SB-10055855-1429

Technical Service Bulletin

94 Daytime running light (DRL) inoperative (DTC 02895 or 02897)

94 14 38 2032184/3 April 7, 2014. Supersedes Technical Service Bulletin Group 94 number 13-21 dated July 9, 2013 for reasons listed below.

Figure 3. Current (left) and early (right) style LED DRL units.

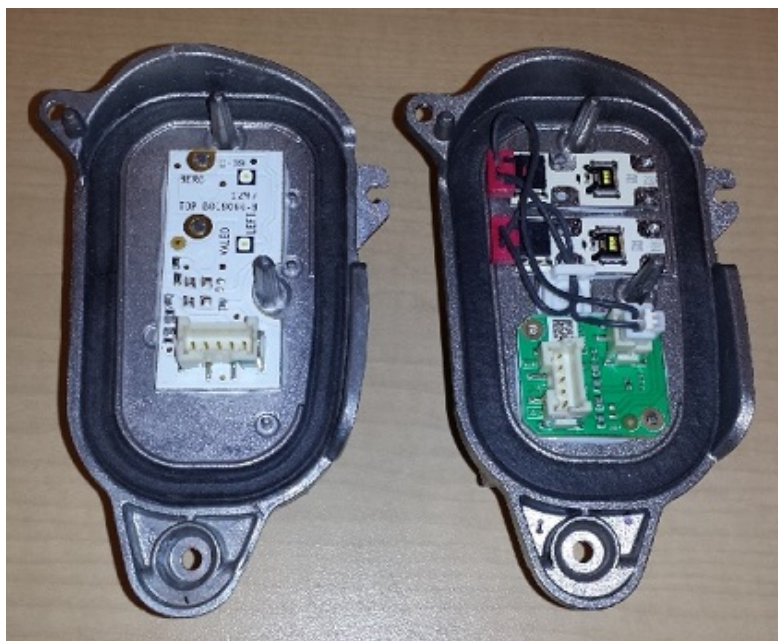
As of March 12th, 2013 production, the LED unit with heat sink has been updated (Figure 3). If a failure occurs, these parts do *not* need to be replaced in pairs.

The appearance of the replacement part for the LED DRL has changed, but functionality is the same. If an LED DRL needs to be replaced, they do not need to be replaced as a pair.
